**Development Special Use Permit #2018-0007,  
Transportation Management Plan Special Use  
Permit #2018-0062  
1200 N. Fayette Street**

## **I. SUMMARY**

### ***A. Recommendation***

**Figure 4** – Vision Clearance Modification

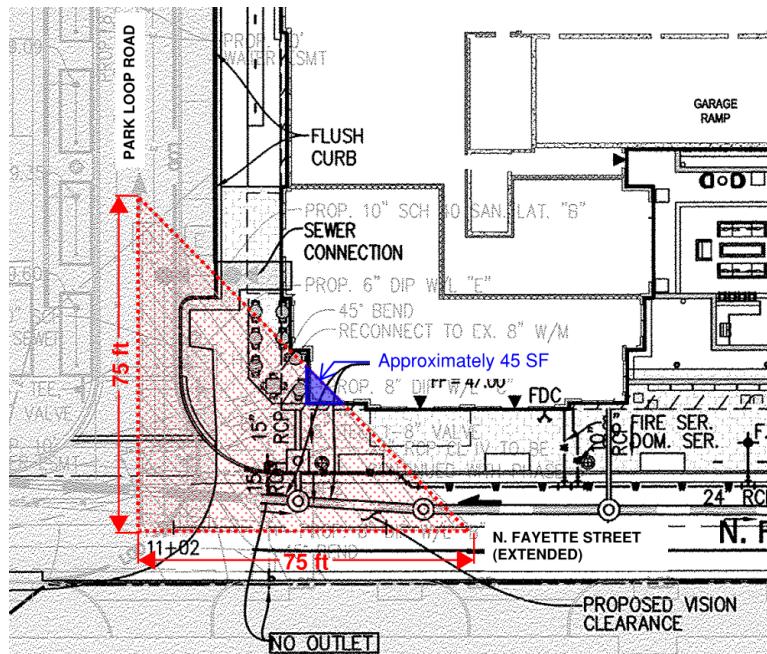
Per Section 7-801, buildings with corner frontage or on corner lots shall have no structure or other obstructions "within the area enclosed by the centerline of the intersecting streets and a line joining points on such centerlines at distances from their intersections." A setback of 75 feet (shown in red, Figure 4) is required at the corner of N. Fayette Street and the future park loop road. The applicant requests a modification of this setback for approximately 45 square feet (shown in blue, Figure 4) of building area that occurs within this vision clearance.

1. This modification is desirable for the building to maintain the urban street wall along the extension of N. Fayette Street. Further, this corner is the location of the retail space which fronts the community park. Maximizing this retail space aids in further activation of the corner and community park.
  2. The approximately 45 square foot building area which falls within the required vision clearance is limited to a height of 27 feet measured from the average

finished grade. At this point, the building steps back, creating “shoulders” along N. Fayette Street as required by the BMNP.

3. The requested modification will have minimal impact to the area and no detrimental effect on property, as the adjacent streets are designed to handle low-speed traffic in a to-be highly walkable portion of the City.

## Attachment #3 – Building 3B Materials Revised (Diagram)

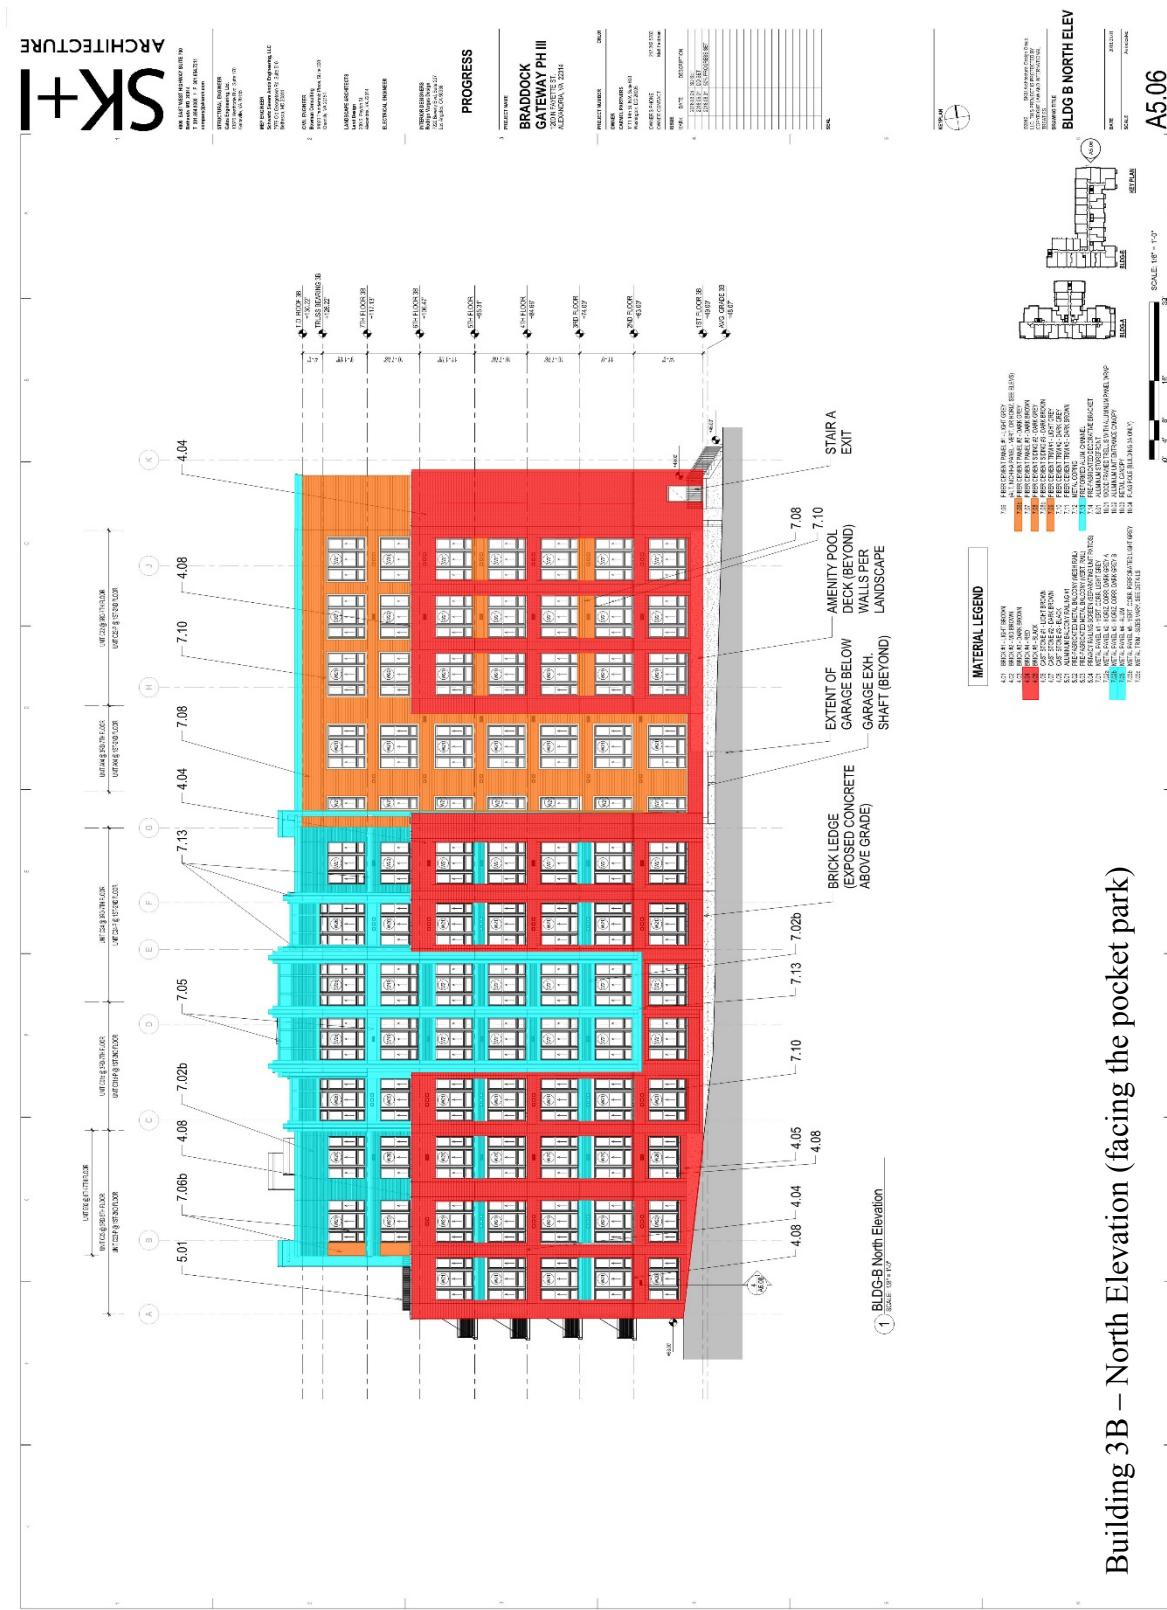
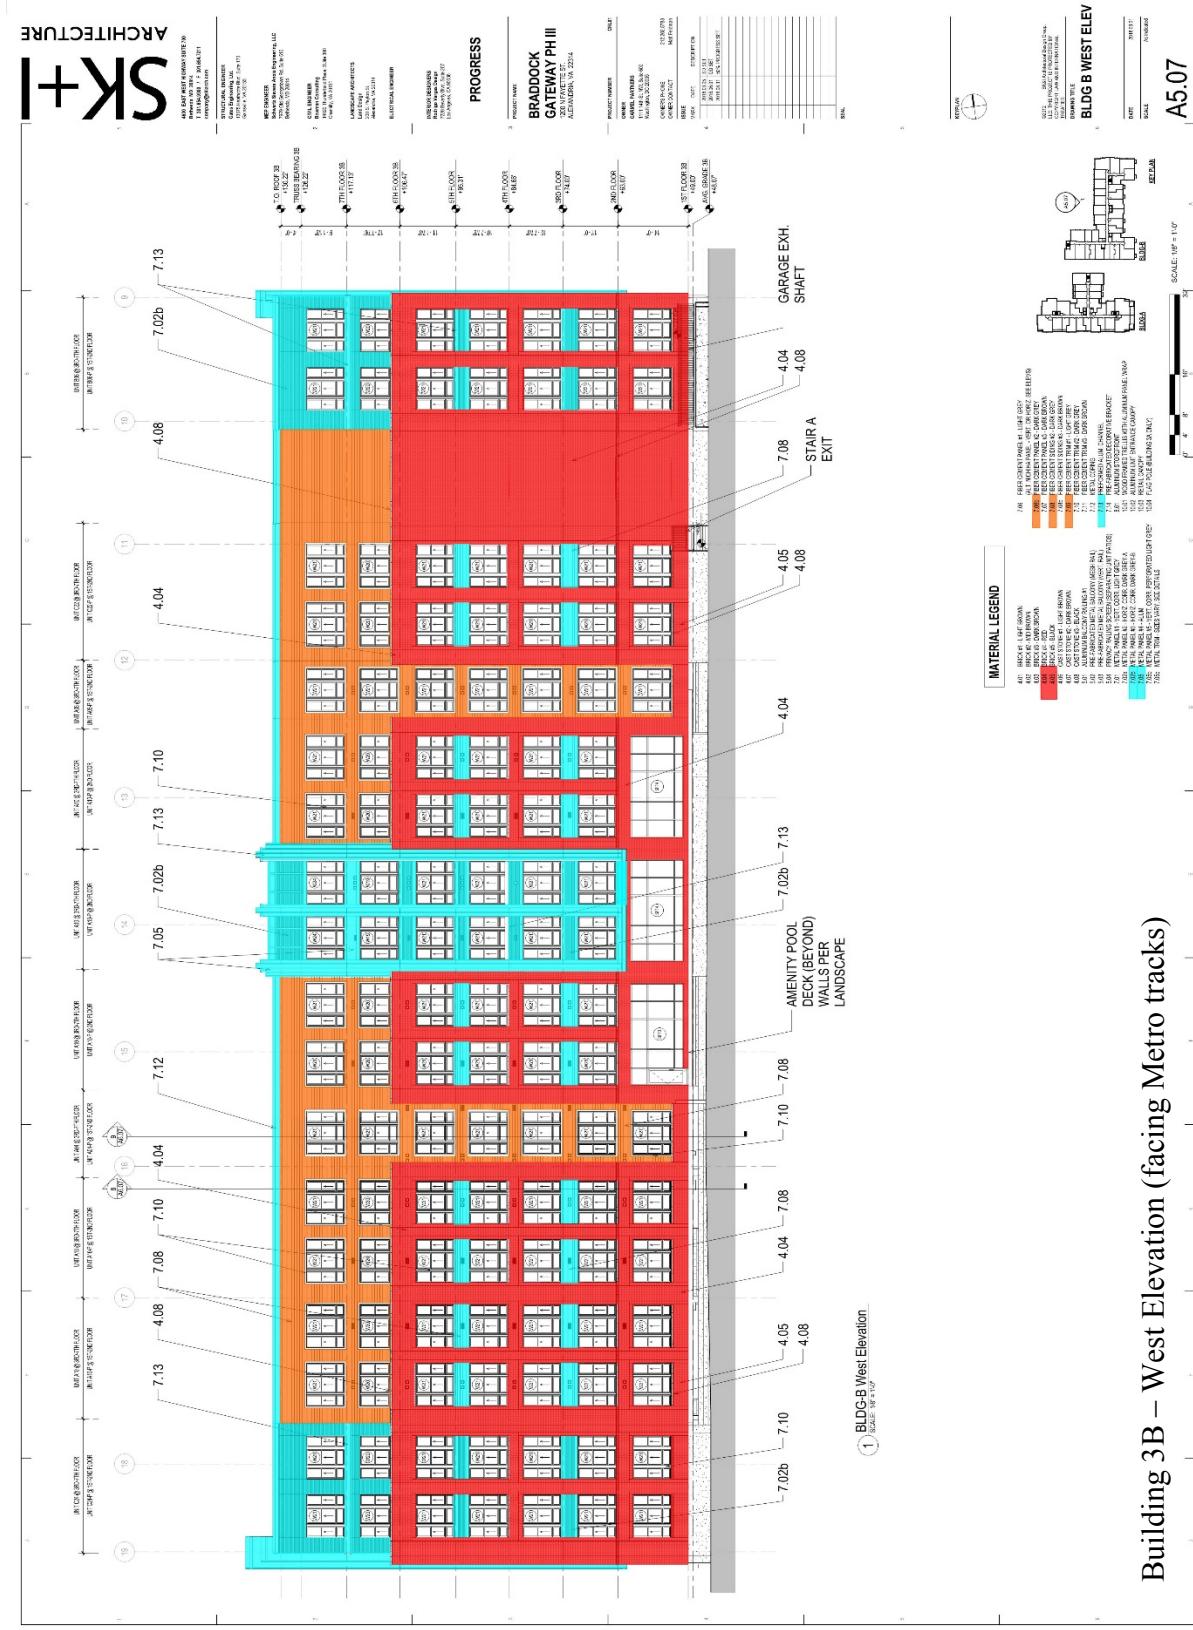
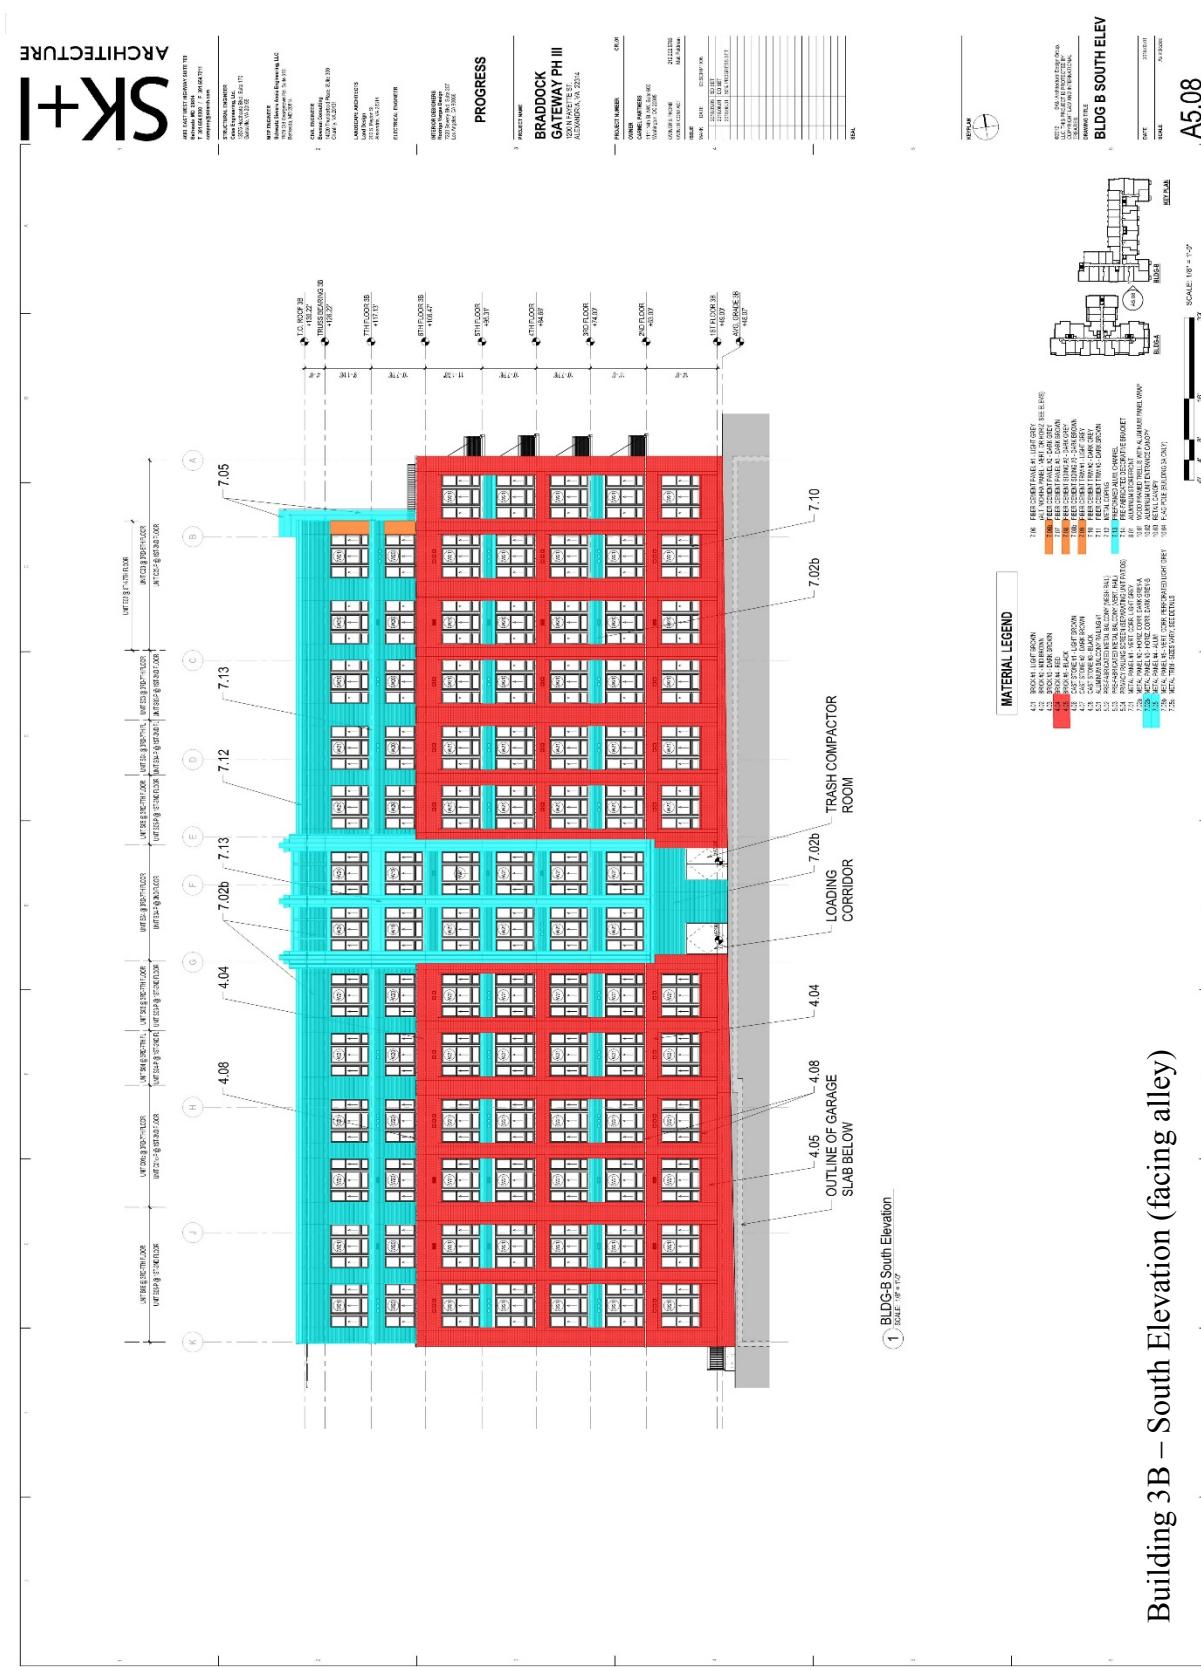
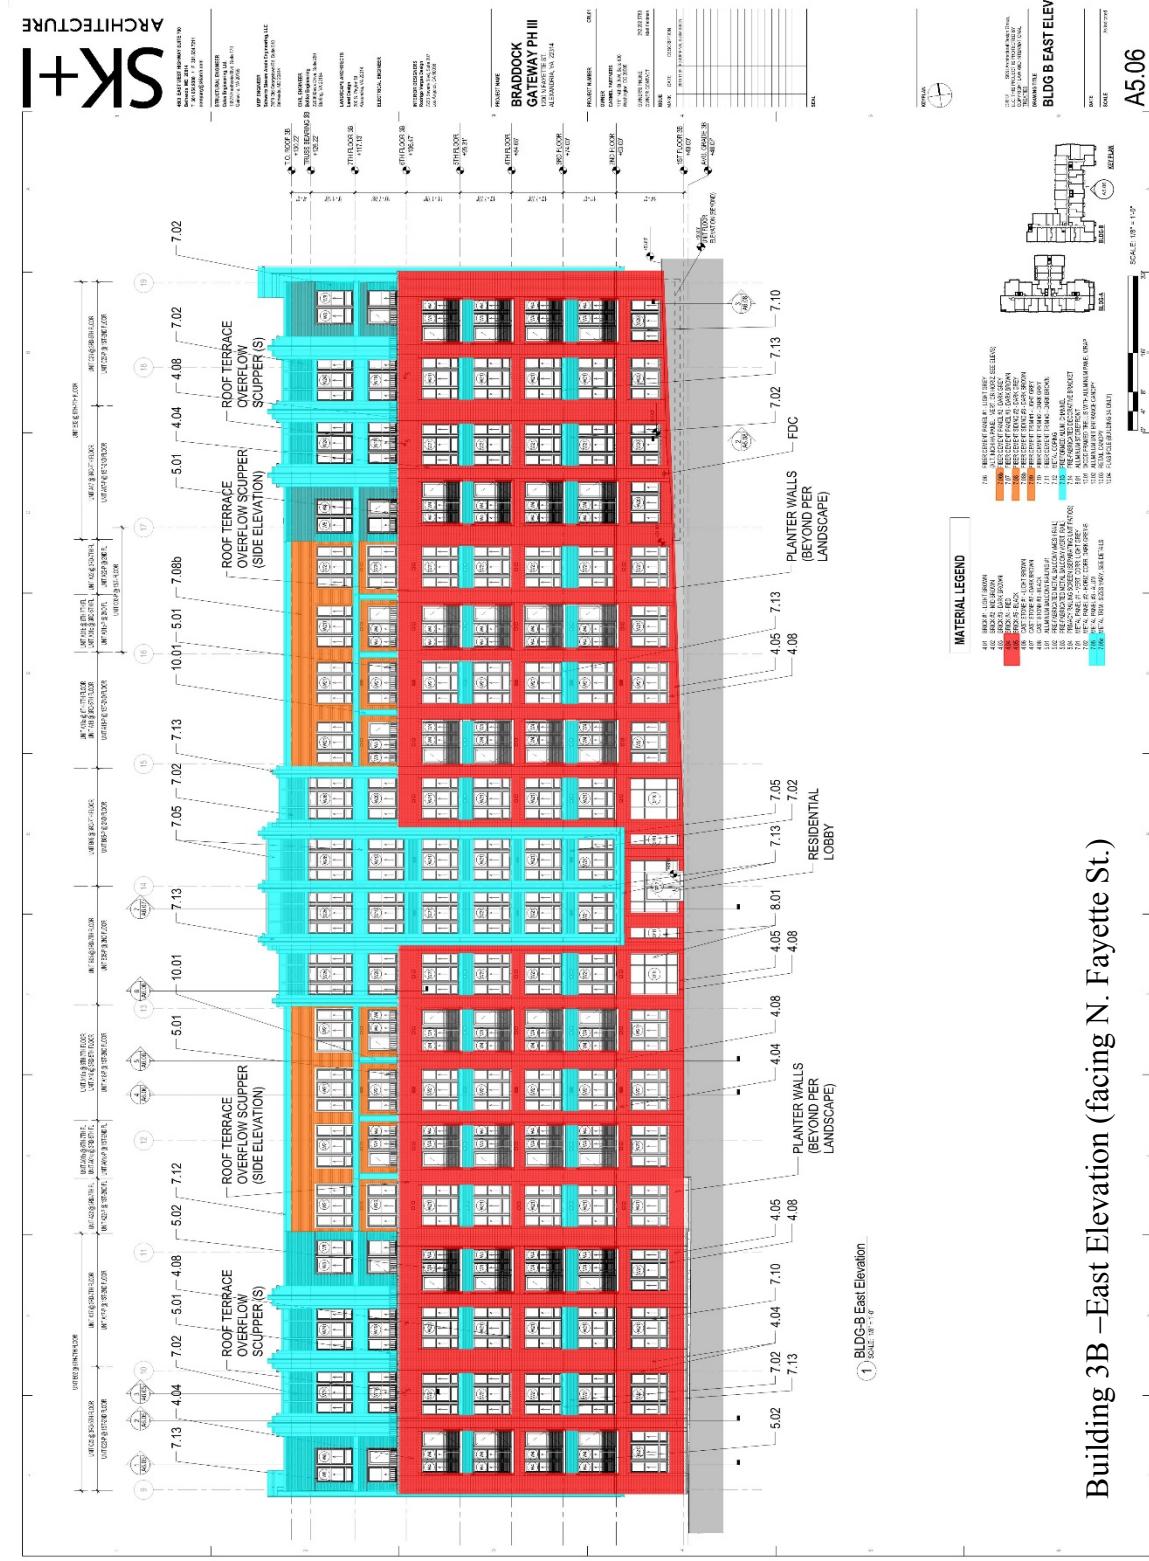
with the verticality of the upper floors of these facades topped with gray paneling. Due to the limited visibility of the west and north facades of Building 3A, Staff worked with the applicant to maximize masonry and metal materials on the south and east facades with some allowance for fiber-cement paneling where it is less visible. The material colors are primarily warm tones with cream and brown hues intermixed with gray paneling that provide contrast. The brown masonry creates a banding effect which assists with breaking down the scale and defining the base of the building.

The brick material on the first 5 floors continues around the less visible south and west facades, with gray paneling primarily utilized at the first 2 floors of the building and extended vertically at periodic interruptions of the brick to demarcate secondary entrances to the building and relate to the north and east facades. Following submission of the Preliminary Plan, the applicant contacted Staff to discuss revisions to the materials of Building 3B. The applicant described significant concerns for the project’s viability if some costs are not recouped due to the rising construction costs of today’s economy. Staff reviewed the revised materials in detail and worked closely with the applicant to ensure that any substitutions do not sacrifice the overall architectural and aesthetic quality of the building. This was done by limiting substitutions of metal for fiber cement paneling to the least visible facades to the south, facing the alley, and west, facing the metro tracks. Some fiber cement paneling is substituted for metal panel on the east façade; however, this area is set back from the road and only occurs on the recessed portion of the upper floors on the building, where its visibility is further minimized by the presence of a freestanding pergola at the seventh floor. Overall, the most prominent and visible areas of the building materiality remain unchanged, including the gateway feature and the most visible portions of the east façade. Graphics which diagram the changes are included as Attachments #2 and #3 at the end of this report.
